RE: Town of the Pas – Wastewater Treatment Lagoon Upgrade and Sludge Land Application EAP (File No: 144.40) – Response to Comments from Manitoba Sustainable Development - Environmental Approvals Branch

THE TOWN OF THE PAS

SLUDGE DEWATERING CELL

PLAN AND SECTIONS

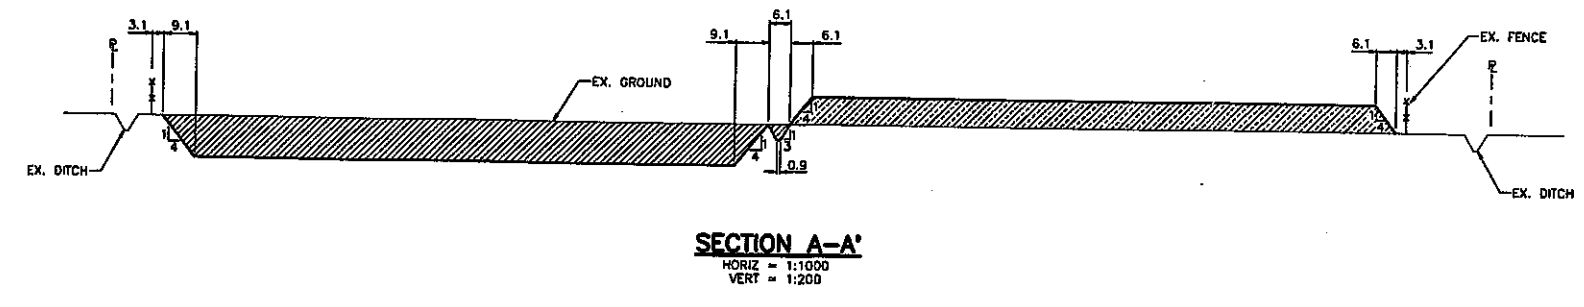
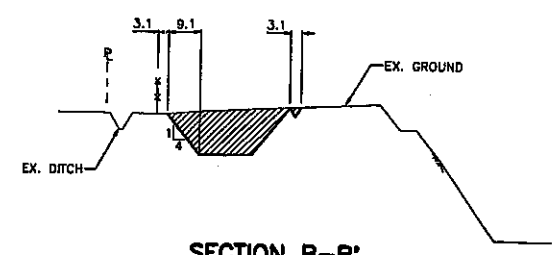
- 1. Please update the engineering drawings with the cross section details including the type of liner material present in the existing aerated cell and in the dewatering cell.**

Due to the age of the original lagoon construction there are no design drawings which show details of the lagoon liner, however it is estimated that the lagoon dikes were constructed from excavated and compacted soil material from the cell construction area. To our understanding no geotechnical investigation has occurred on the existing lagoon dikes to confirm the liner composition, therefore detailed cross section drawings of the existing lagoon dikes cannot be produced at this time. A 1996 design drawing from UMA Engineering (attached) indicated that muskeg was removed from the construction and replaced with a minimum of 0.9 m of compacted clay.
